Model: PRIORT PEARL/PEARL-MC/RUBY/SAPPHIRE/GARNET/SA2/SA2P		Date: 25-Jun-07	No: R-C235-001
Subject: Patchy image		Prepared by: M. Kumagai, Priort Service Planning Section	
Classification:	<input checked="" type="checkbox"/> Troubleshooting <input type="checkbox"/> Part information <input type="checkbox"/> Action required <input type="checkbox"/> Mechanical <input type="checkbox"/> Electrical <input type="checkbox"/> Service manual revision <input type="checkbox"/> Paper path <input type="checkbox"/> Transmit/receive <input type="checkbox"/> Retrofit information <input type="checkbox"/> Other ()		
Model Name: SAPPHIRE: Ricoh JP8000, Gestetner 5490, RexRotary 1395, nashuatec CP490, Savin 3450DNP, Standard SD630 GARNET: Ricoh JP5500, Gestetner 5450+/5455, RexRotary1560+, nashuatec CP450+, Savin 3360DNP, Standard SD450, Lanier LDD150 SA2: Ricoh JP8500, Gestetner 5490+/5499, RexRotary1395+, nashuatec CP490+, Savin 3460DNP, Standard SD650, Lanier LDD180 SA2P (China only): Ricoh JP8510P, Gestetner 5500P

Model: PRIPORT PEARL/PEARL-MC/RUBY/SAPPHIRE/GARNET/SA2/SA2P		Date: 3-Jul-07	No: R-C235-002
Subject: betterment for ink leakage		Prepared by: M. Kumagai, Priport Service Planning Section

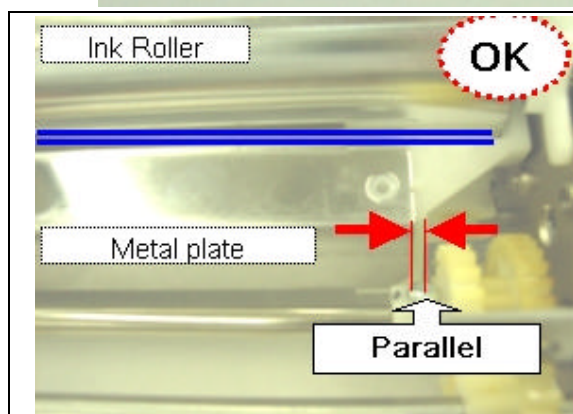
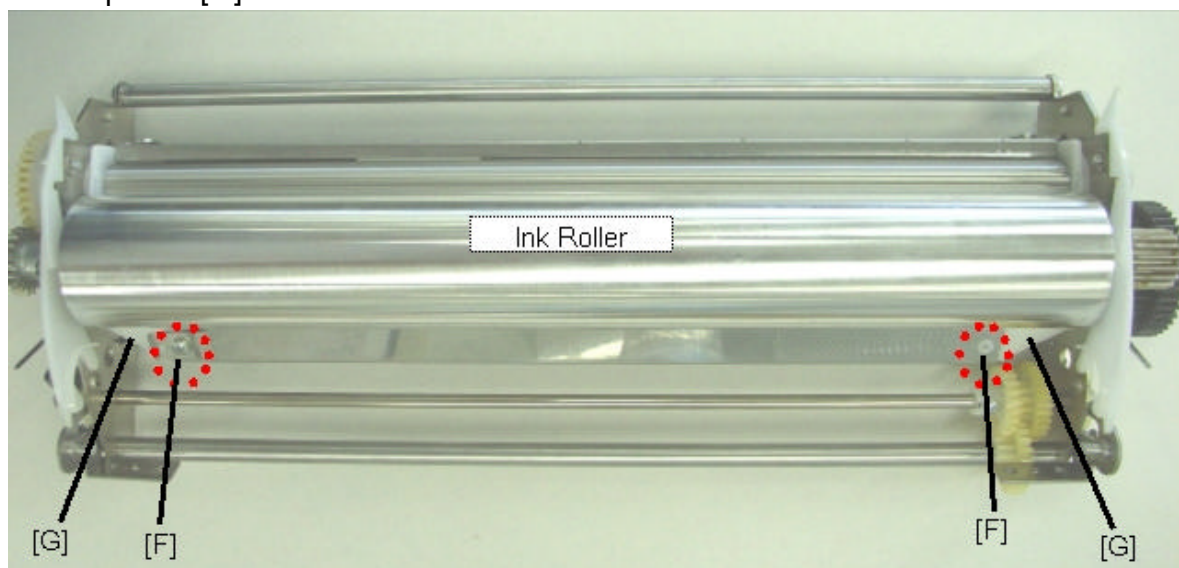
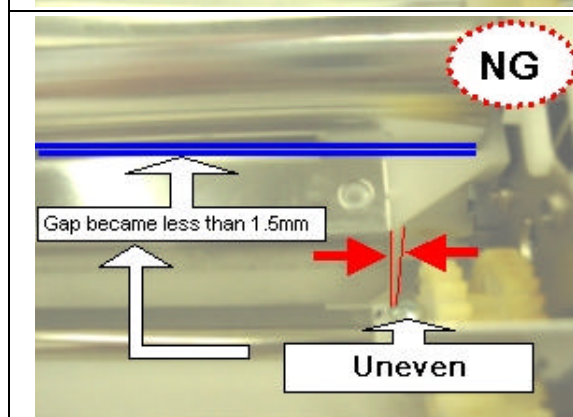
SYMPTOM: Faint images.

The gap between the metal plate [A] and ink roller [B] is too narrow (Less than 1.5mm). As a result, the ink on the ink roller builds up on the metal plate. This ink [E] then moves to the ink detection pins [C] or ink distributor [D]. If the ink builds up on the ink detection pins, the machine will mis-detect the amount of the ink inside the drum. If ink builds up on the ink distributor, ink will not flow smoothly inside the drum.

SOLUTION: Adjust the gap between metal plate and ink roller to more than 1.5 mm.

1. Loosen the two screws [F] attached to the metal plate.
2. Adjust the gap to **more than 1.5 mm**.

Important: Make sure both sides of the metal plate are parallel to the separation plates [G].

1. Both ends of the white mold parts and cleaning blade are **parallel**.
2. The gap between the edge of the cleaning blade and ink roller is **over 1.5mm**.

1. Both ends of the white mold parts and cleaning blade are not parallel.
2. The gap between the edge of the cleaning blade and ink roller is 1.5mm or less.
Note: This can happen if the white mold parts get jammed at the side of the ink roller and bend.

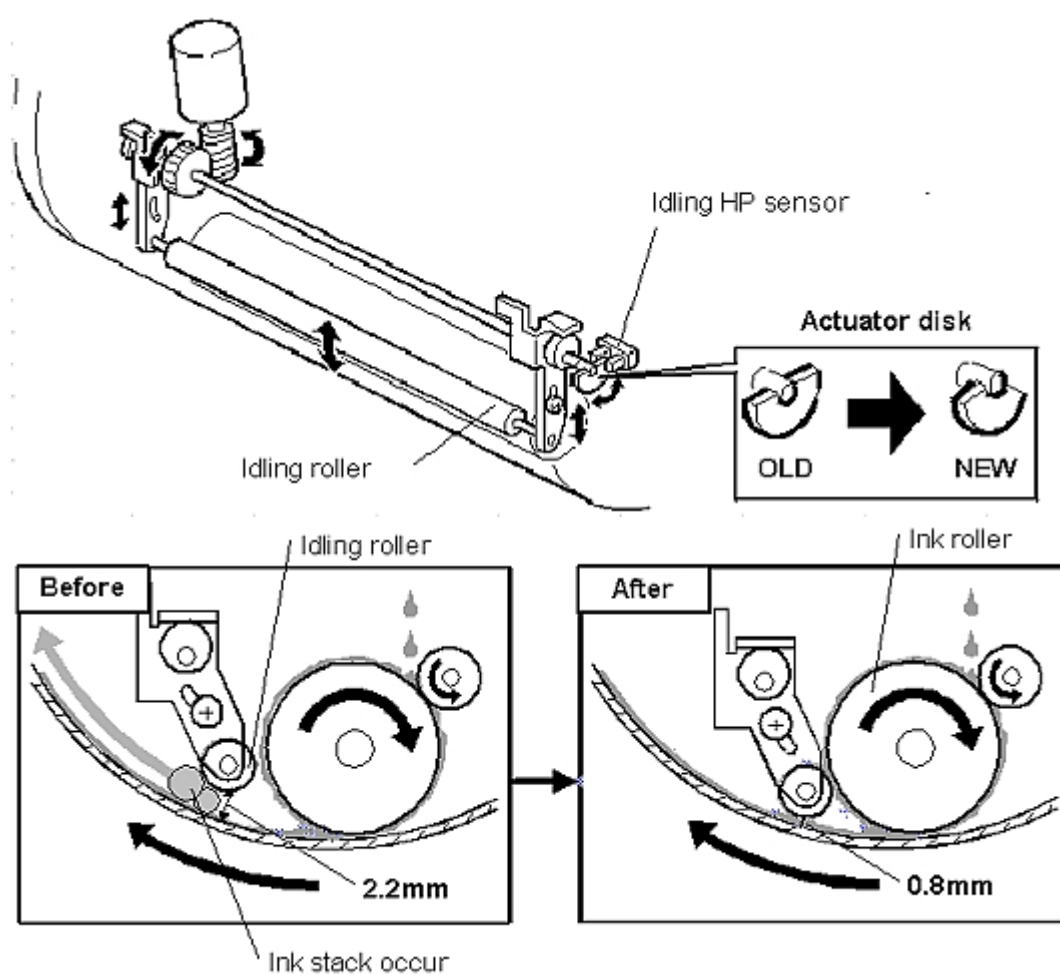
Ink leaks or sticks to the inside of the drum, generating SC5-22 (no drum shift sensor pulse) or SC5-32 (ink pump sensor remains off).

Lumps of ink build up on the ink pump motor, and eventually the ink begins dropping into the drum.

The shape of the actuator for the idling HP sensor was changed.

Note: As a result, the gap between the idling roller and metal screen is now narrower than before (2.2 mm to 0.8 mm). The idling roller will be rotated with the metal screen, which will prevent the ink from building up.

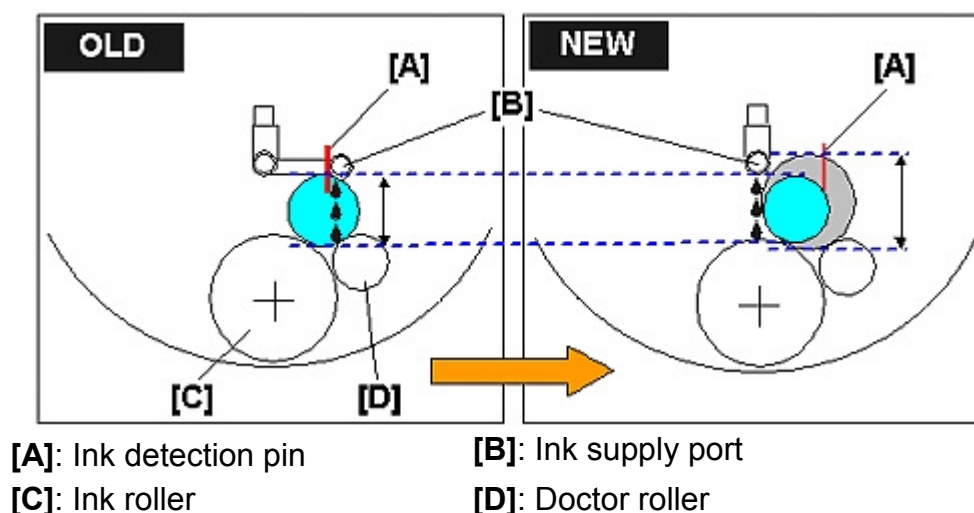
The "No ink" condition is detected by mistake.

Ink sticks to the ink roller [C], and then builds up on the ink detection pin [A] and ink distributor.

The ink distributor and attachment bracket for the **Emerald/Topaz** are now used. The distance between the ink detection pin and ink supply port [B] is wider. Also, it is harder for ink to stick to the ink detection pin and ink distributor.

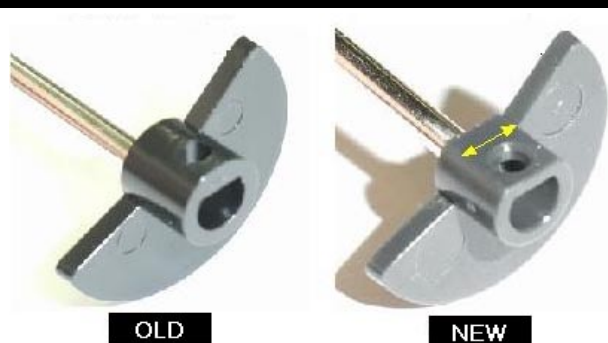
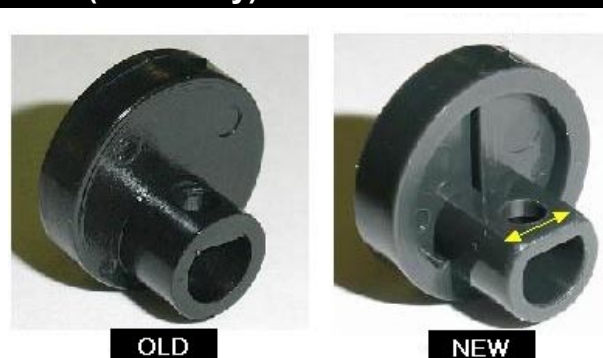
- The shapes of the actuator disk and cam were changed to ensure that the screw stays more securely in place (see the photos).
- The threaded part of the screw was treated with a coating that locks the screw in place.

Replace the cam (C239 only) and actuator disk, using the new screw.

Note: The cams on SAPPHIRE/SA2/SA2P are also changed to flat from halfway.

So refer to MB# MC235007 and change to new parts if the machine contains old parts.
